Task 2: Investigation of the Existing Conditions for Compliance

TECHNICAL MEMO 2 - RECOMMENDATIONS

PROJECT: Kalorama Park (Volkert No. 230405.60)

DATE OF REPORT: June 29, 2012

TP#1 - Test Pit No. 1:

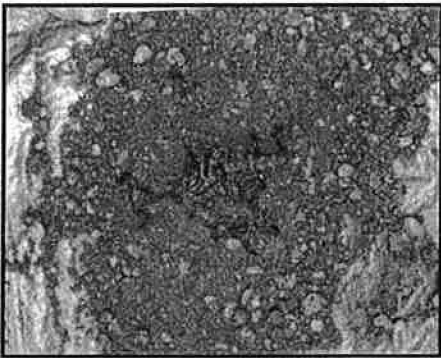
The top layer of test pit #1 consists of clay like medium that appears to be bonded together. Grass has not established to a satisfactory condition and appears in only small patches. At 6" we encountered a slightly loamy sand mix.

OBSERVATION	INITIAL RECOMMENDATIONS
See Above.	Remove top 12" of material and provide suitable mix.

TP#1: 12"-18"

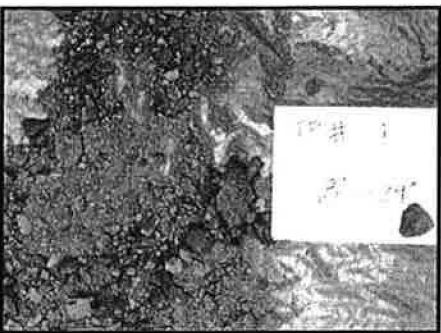
At 12 to 18 inches, we encountered layers of sand and construction debris, such as filter fabric. The filter fabric layer was found at 18" between two layers of sand. The sand layers were 2"-3" thick each.

TP#4 - Test Pit No. 4:

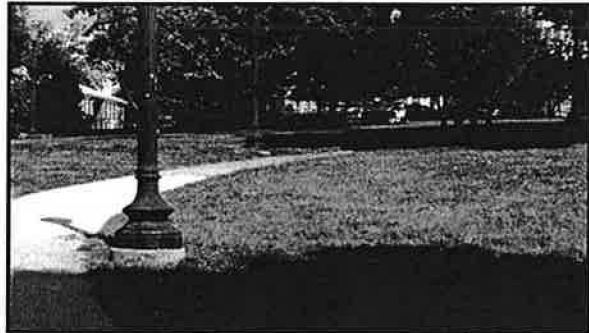
At 0 to 12 inches we encountered soil mixed with sand, clay and construction entrance debris. Soil excavation was hindered by numerous stones and hard soil.

Review of the construction drawings indicates that this area was a construction entrance during the construction of the site improvements. The stones and the hard subsurface encountered may be the result of improper removal of the construction entrance material.

- Remove top 36" of material and provide suitable mix.
- Treat with sod or seed.

TP#5 - Test Pit No. 5:

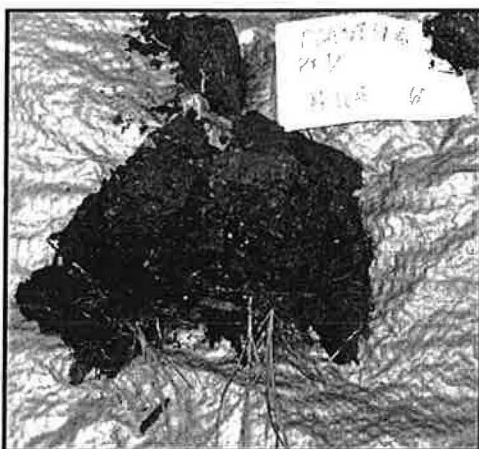
At 0 to 12 inches we encountered natural soil. Soil appeared to be slightly dryer than expected, but otherwise acceptable.

- Remove top 6" of material and provide suitable mix.

TP#6 - Test Pit at Planting Bed:**TP: 0"-6"****TP#6: 0"-6"**

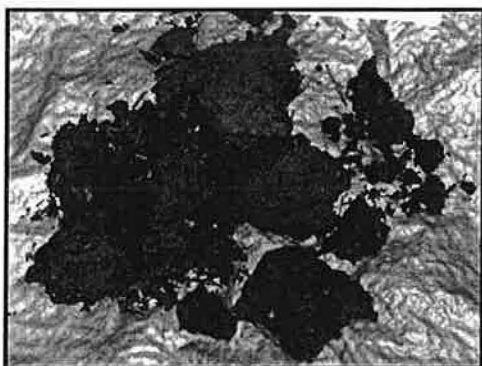
At 0 to 6 inches we encountered a layer of mulch on wet soil. The clay like medium appeared to be inadequate. However, the plants appeared healthy. Roots of shrubs have spread through the planting medium. Weeds are abundant. Roots of weeds remain on the top 1 inch of the planting soil.

At 6 to 12 inches the soil medium was continuously moist with minor construction debris.

Remove weeds (Also see recommendations in the Plantings section).

Berm B2

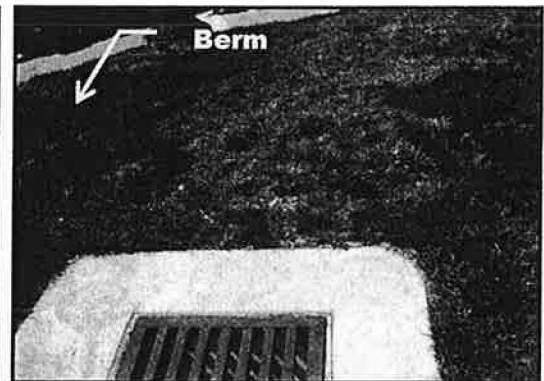
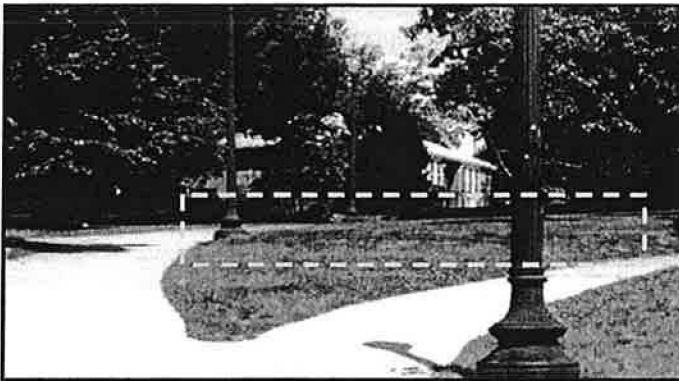
<i>OBSERVATION</i>	<i>INITIAL RECOMMENDATIONS</i>
<ul style="list-style-type: none">• Bioswale appears to be working normally.• Berm is mostly well covered with lawn. In some area, bare patches appear.• Catch basin at the end of bioswale is dry.	<ul style="list-style-type: none">a. Treat area with seed or sod.b. Flush catch basin and cleanout pipes.

Berm B3

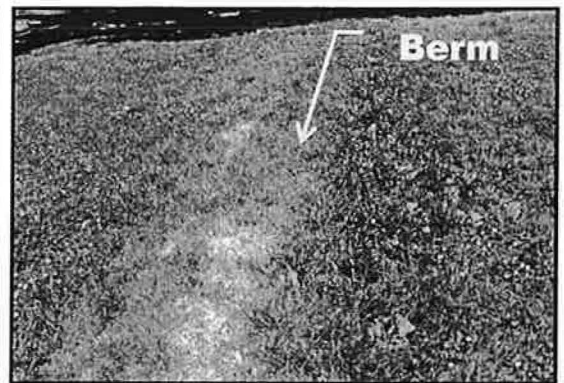
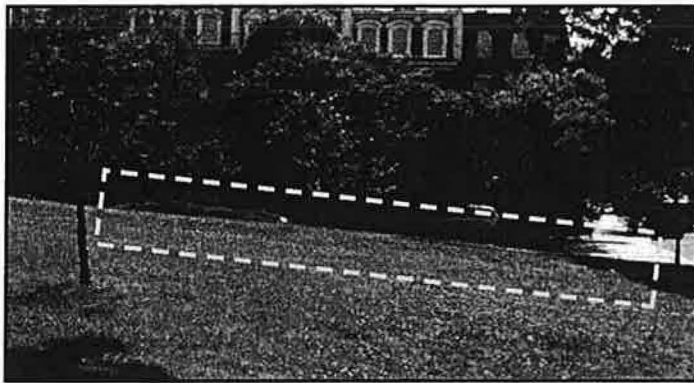
<i>OBSERVATION</i>	<i>INITIAL RECOMMENDATIONS</i>
<ul style="list-style-type: none">• Bioswale appears to be working normally.• Berm is mostly well covered with lawn. In some area, bare patches appear.• Catch basin at the end of bioswale has miscellaneous debris.	<ul style="list-style-type: none">a. Prepare bare areas around the catch basin for new lawn.b. Treat area with seed or sod.c. Remove debris in catch basin. Flush catch basin and cleanout pipes.

Weeds

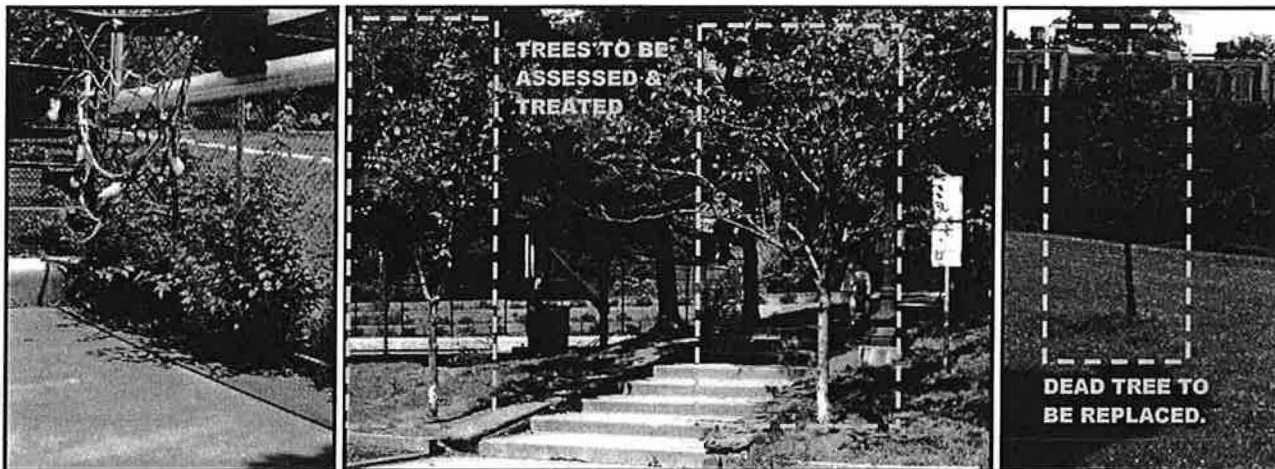
There are weeds throughout the site.

a. Remove weeds.

Pruning & Trees

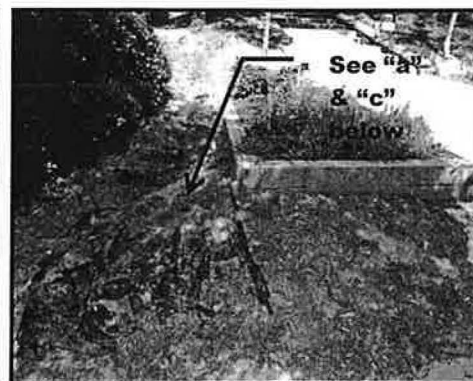
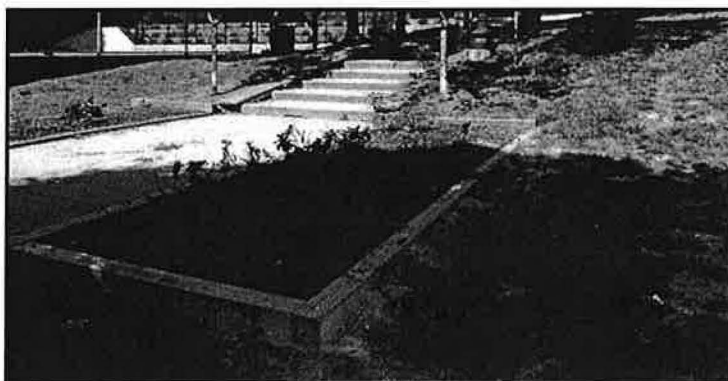
OBSERVATION	INITIAL RECOMMENDATIONS
<ul style="list-style-type: none"> Vines and trees are hanging over planted materials and site features. Trees at the 19th Street NW entrance into the park appear to be in poor health. Roots may have been damaged from construction activity. 	<ol style="list-style-type: none"> Prune shrubs and ground cover. Have tree roots pruned and treated by arborist. Trees that are dead or dying should be replaced or treated as directed by arborist.

Concrete Wall and Paving

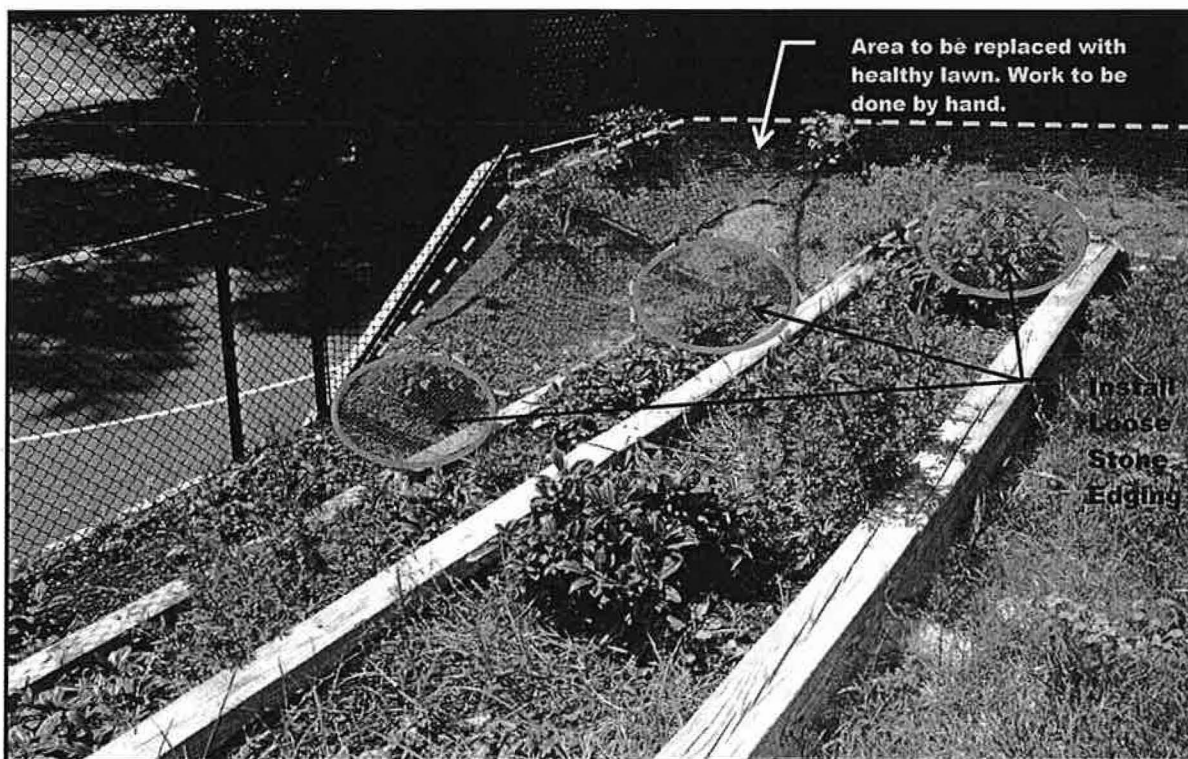
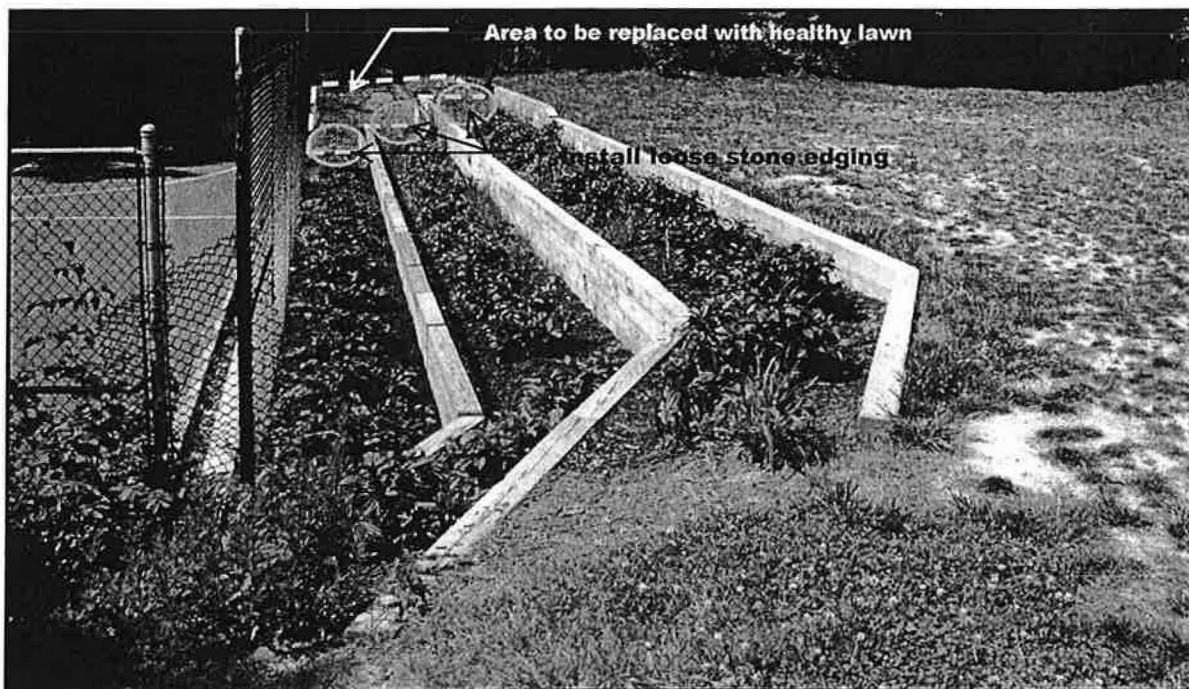
OBSERVATION	INITIAL RECOMMENDATIONS
<ul style="list-style-type: none">• Pavement between basketball court and retaining wall is missing and hazardous.• Foundation of previously existing basketball court remains in place, and is an obstruction to anyone using the court.	<ul style="list-style-type: none">a. Remove top 12" of old basket ball hoop concrete foundation.b. Install basketball court surface with a concrete base at gap between retaining wall and existing court. Provide a continuous expansion joint between wall and subbase.

F. Fencing

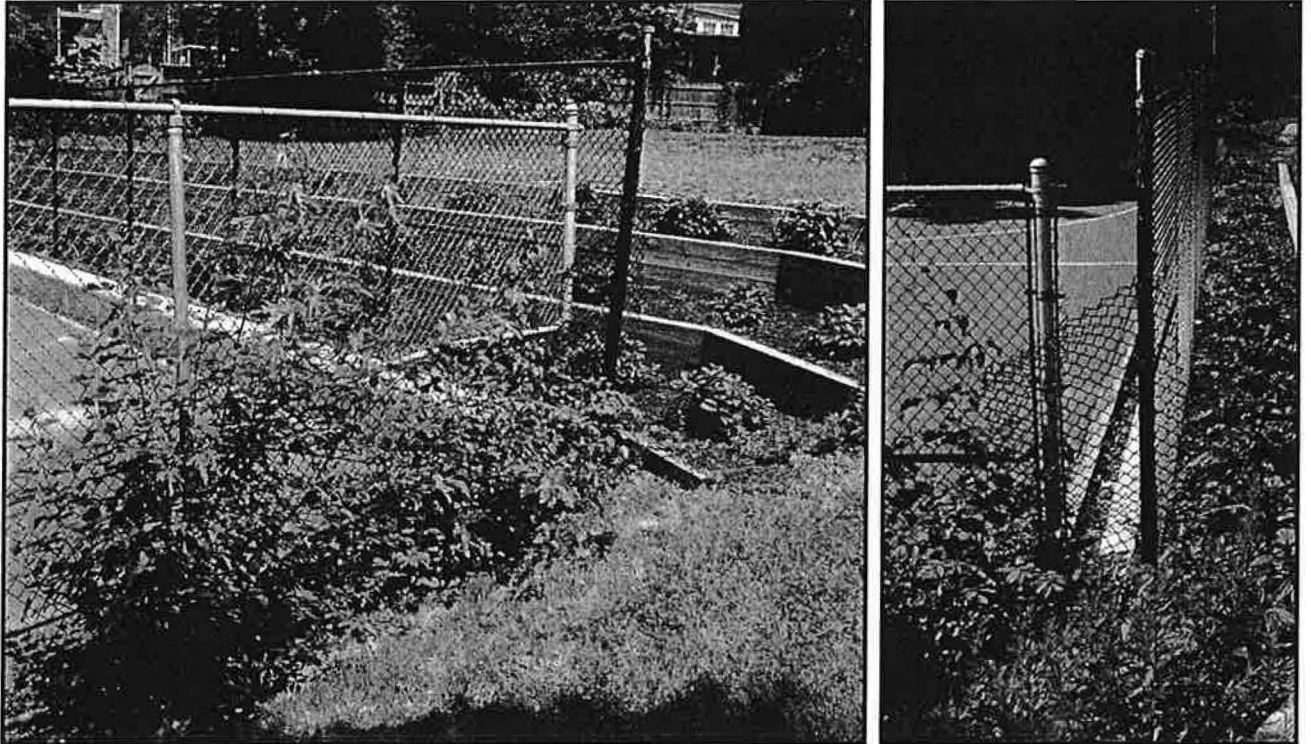
<i>OBSERVATION</i>	<i>INITIAL RECOMMENDATIONS</i>
<ul style="list-style-type: none">• New black fence and previously existing fence are poorly tied together with miscellaneous fence fabric.	<ol style="list-style-type: none">a. Correctly tie new fence fabric to fence posts.
